SERVICE INSTRUCTION

RUNNING MODIFICATIONS ON

ROTAX® ENGINE TYPE 912/914 (SERIES)

SI-912-020R10

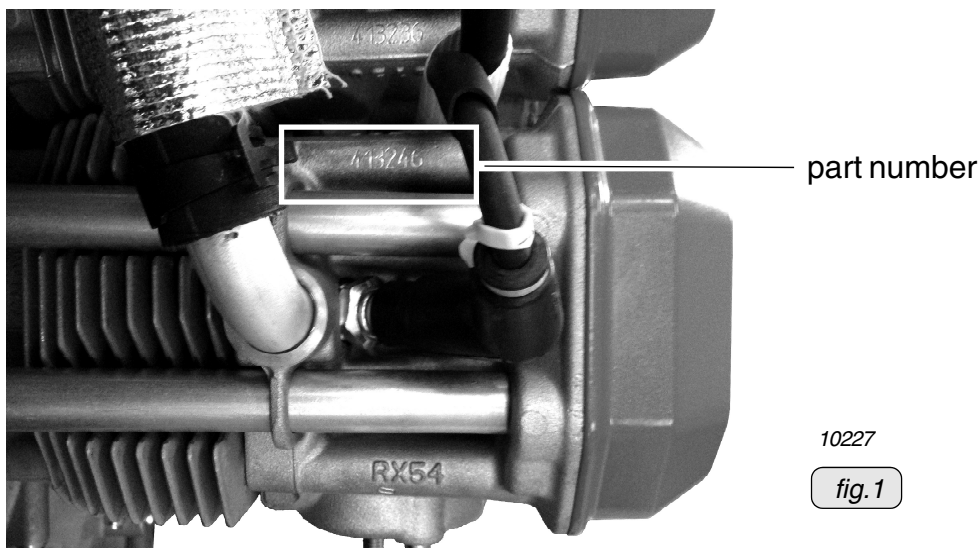
In the course of continuous development and standardization with ROTAX® 912 i Series, a new cylinder head with modifications in its mold has been introduced. Due to these changes the coolant temperature instead of the cylinder head temperature in the aluminium will be displayed. Check the temperature limit for the new positioned measuring point of the cylinder head displayed in the cockpit and if necessary correct its naming (measuring position) and limit.

◆ **NOTE:** Identifying new cylinder heads: The electrical connection of the temperature sensor is pointing upwards. New configuration see fig. 2. Old configuration see fig. 3.

Regarding change of position of the temperature sensor, see fig. 2 and fig. 3.

◆ NOTE: The temperature sensor part no. 965531 and its connection is not changed.

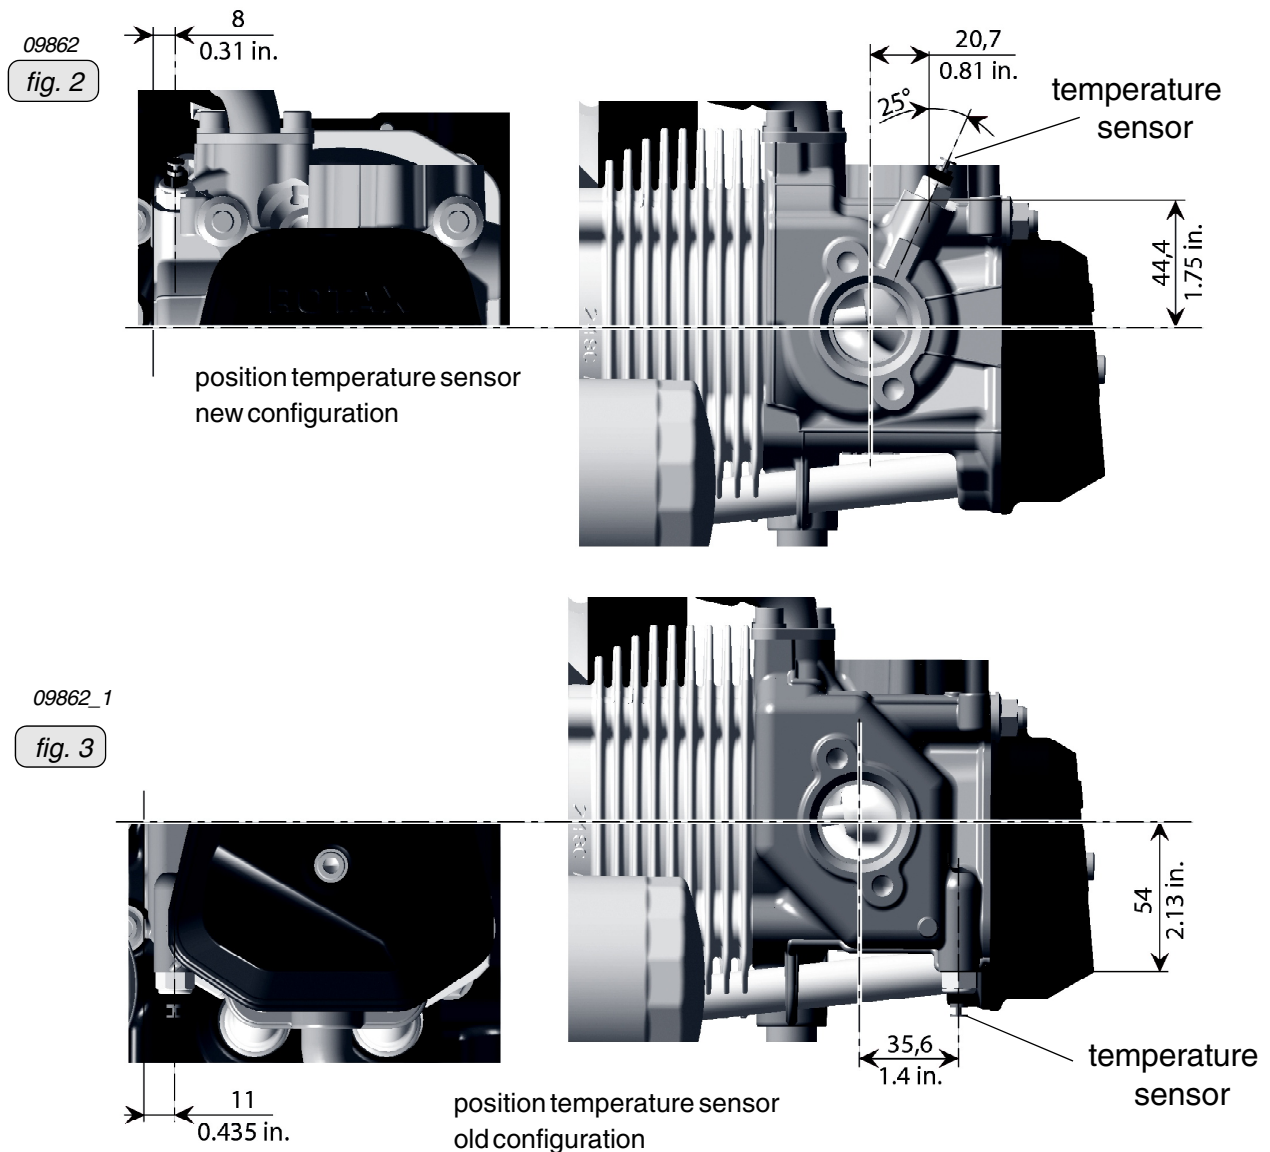
◆ NOTE: Contrary to the current design, the temperature sensor is directly flooded with coolant. Therefore the thread must be sealed with LOCTITE.

1. Clean the thread of the temperature sensor.
2. Apply LOCTITE 243 to the thread of the temperature sensor. Tightening torque 10 Nm (90 in.lb).
3. Plug the respective wiring harness connector into the temperature sensor.
4. Engine assembly.
5. Fill with operating fluids (coolant, oil or fuel). See also chapter 12-20-00 current issue of Maintenance Manual Line for the engine type 912/914 Series.
6. Conduct test run. See also chapter 12-20-00 current issue of Maintenance Manual Line for the engine type 912/914 Series.

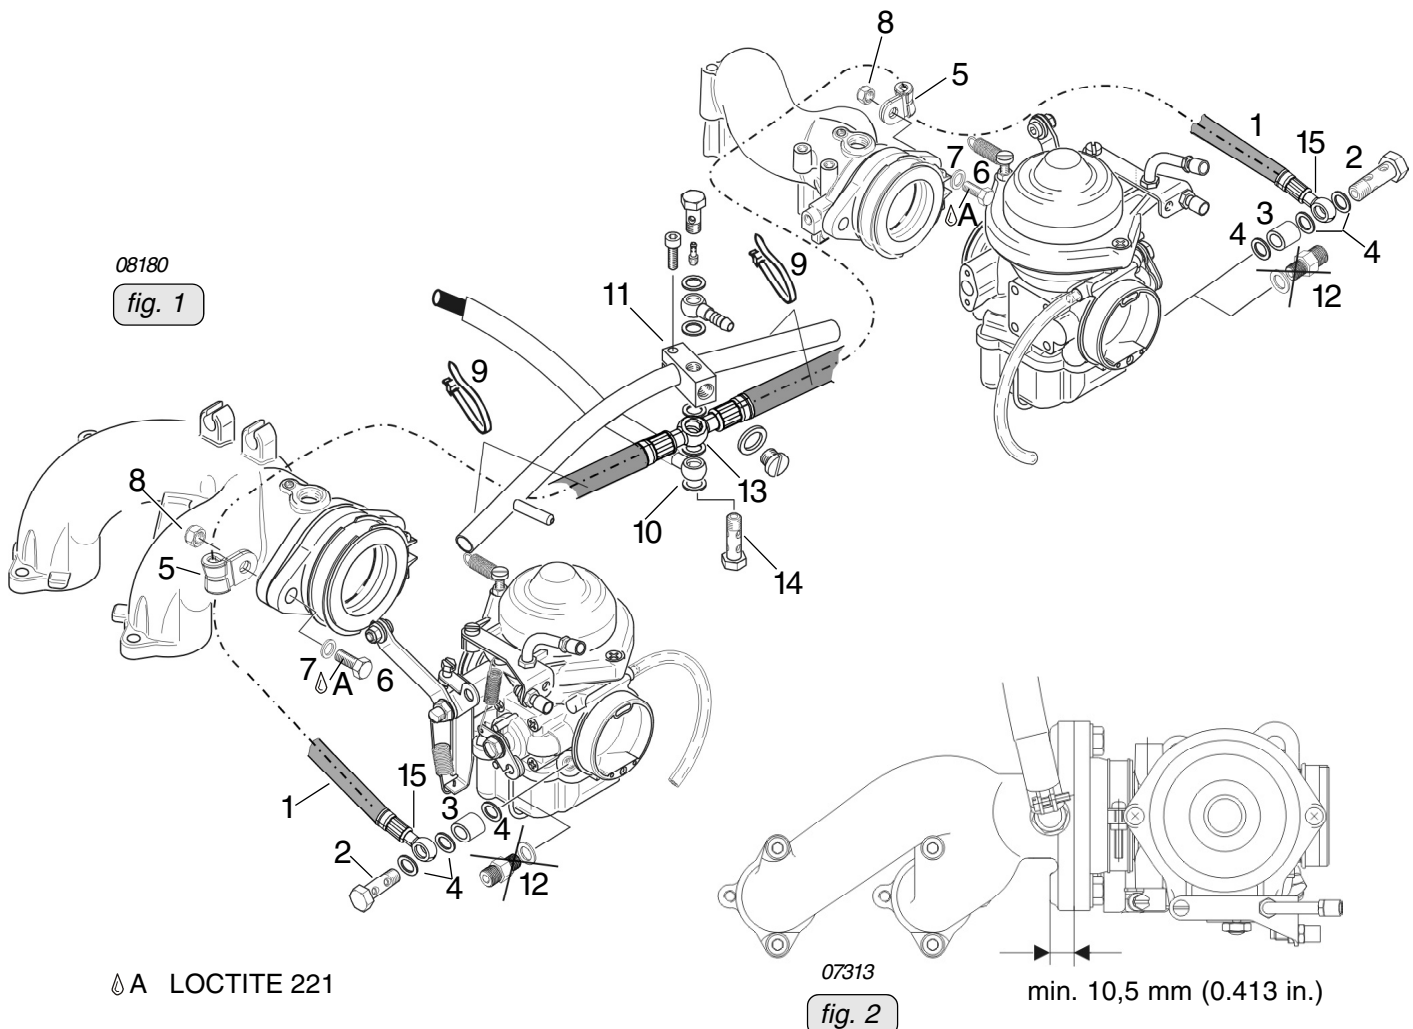
In the course of continuous development and for better assembly and maintenance a new flexible fuel line (part no. 874911) has been introduced.

- mechanical machining at the intake manifold for the attachment of the cable clamp. At engine repair/general overhaul be aware that the fixation of the flexible fuel line needs an appropriate contact surface. If necessary replace the intake manifold or machine the contact surface according to the following instruction.

- Install the flexible fuel line (1) with the double ring hose nipple (13) and sealing ring (10) on the clamp block (11). Tightening torque of banjo screw (14) 10 Nm (90 in. lb.) (see fig. 1).
- Install the ring hose nipple (15) with distance sleeve (3) and sealing ring (4) on the carburetors. Tightening torque of banjo screw (2) 10 Nm (90 in. lb.)

- For installation on an old style intake manifold perform the following: Remove the intake manifold and machine the nut/clamp contact area until the surface is parallel with the sealing surface of the carb socket. The thickness of the material must not be dressed down less than 10,5 mm (0.413 in.) and should be smooth and flat so that the nut/clamp assembly has an even contact surface (see fig. 2).

- Ensure proper support of the flexible fuel line. Install Hex. screw (6) and washer (7) with 15 Nm (133 in. lb.). Install the cable clamp (5) at the hex. screw (6) of the carburetor socket with the hex. nut (8). Tightening torque of hex. nut (8) 24 Nm (213 in. lb.)

08353
fig. 1

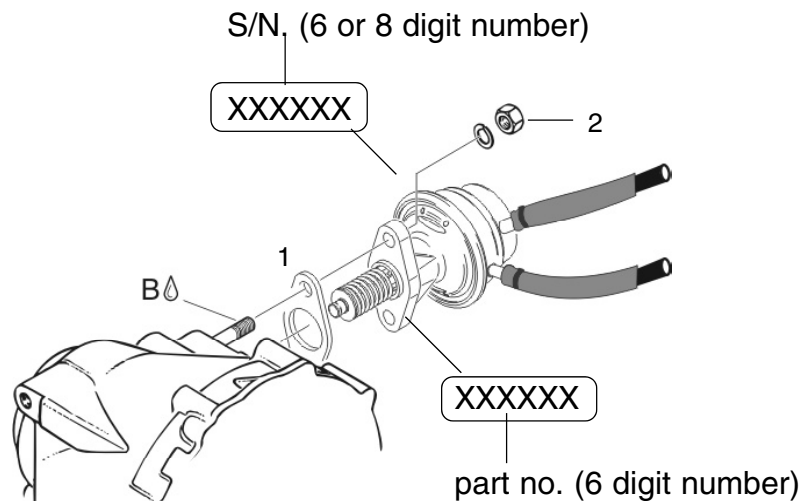
In the course of continuous development a new gasket (1) (part no. 950226) has been introduced.

The gasket is interchangeable.

08371
fig. 1

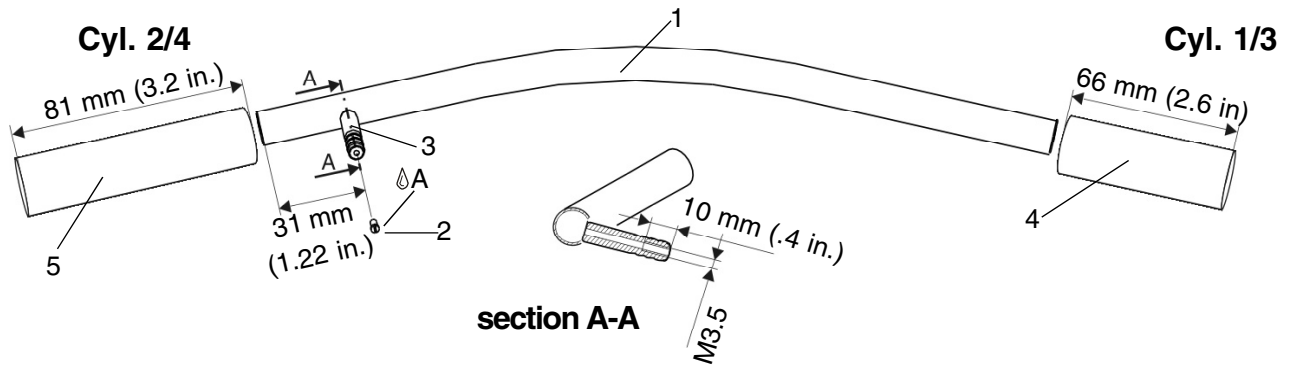
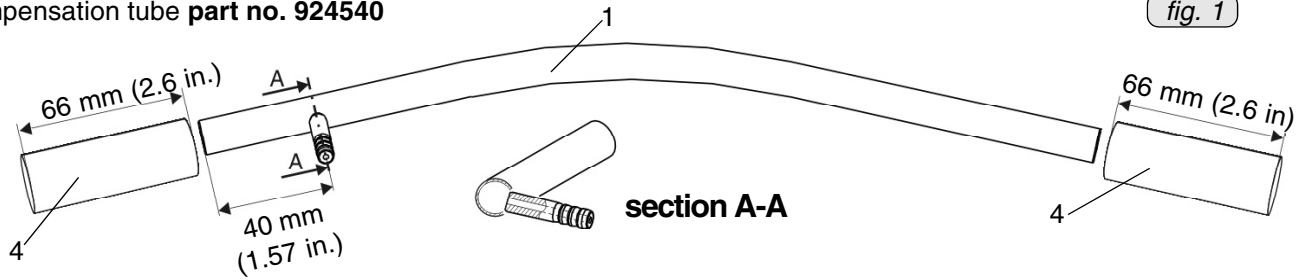
In the course of continuous development a new compensation tube (1) (part no. 924541) has been introduced which need not be removed during carb synchronization, making the process easier to perform.

- position of connection fitting (3) on compensation tube remains approximately constant
- additional screw (2) part no. 940980 for connection fitting (3)
- new tube (4) part no. 956143 (5) part no. 956141

08449
fig. 2

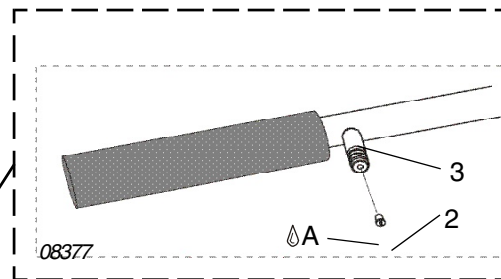
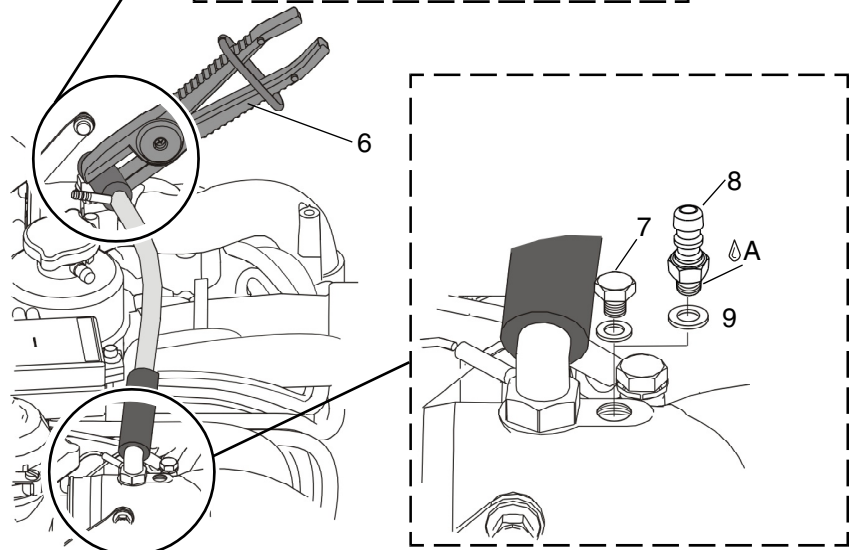
1. Install the vacuum gauge.
2. Clamp the tube with hose clamping pliers (6). Observe the position! The tube (1) must not removed.
3. Unscrew the screw (7).
4. Install the hose nipple M6 (8) with the sealing ring (9).
5. After synchronization tightened the screw M6x6 (7) with LOCTITE 221.

fig. 1

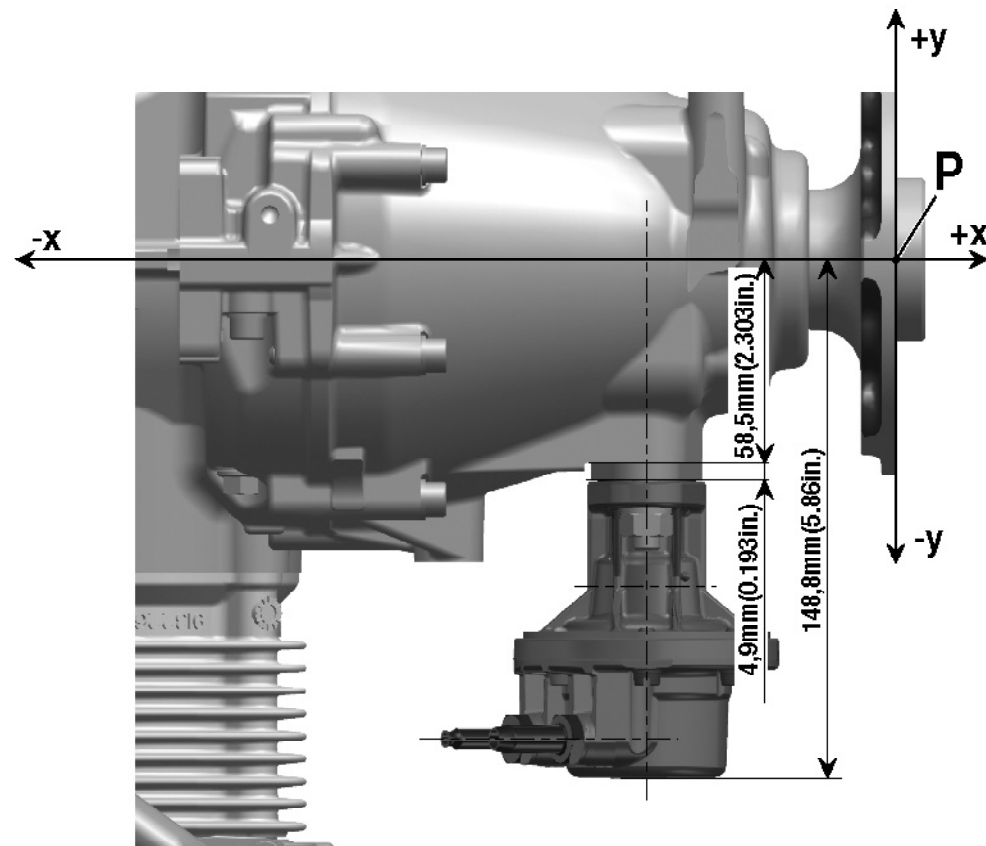
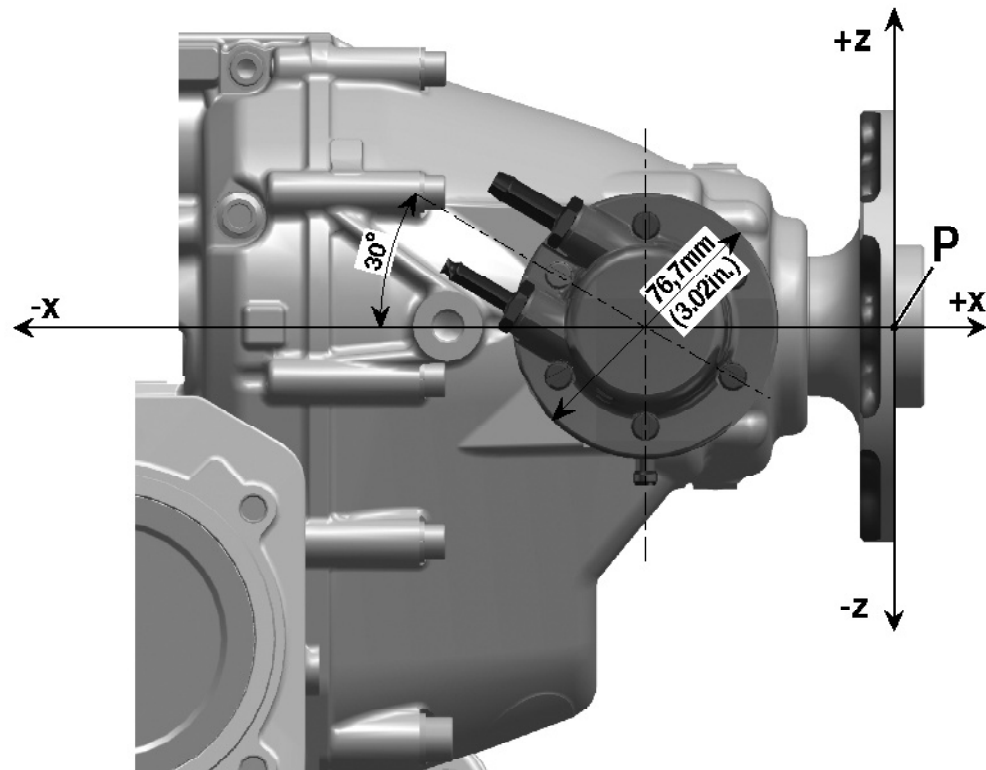
In the course of standardization a new "basic" fuel pump assy. (part no. 893115) has been introduced, which can be configured with the appropriate nipples or fuel hoses.
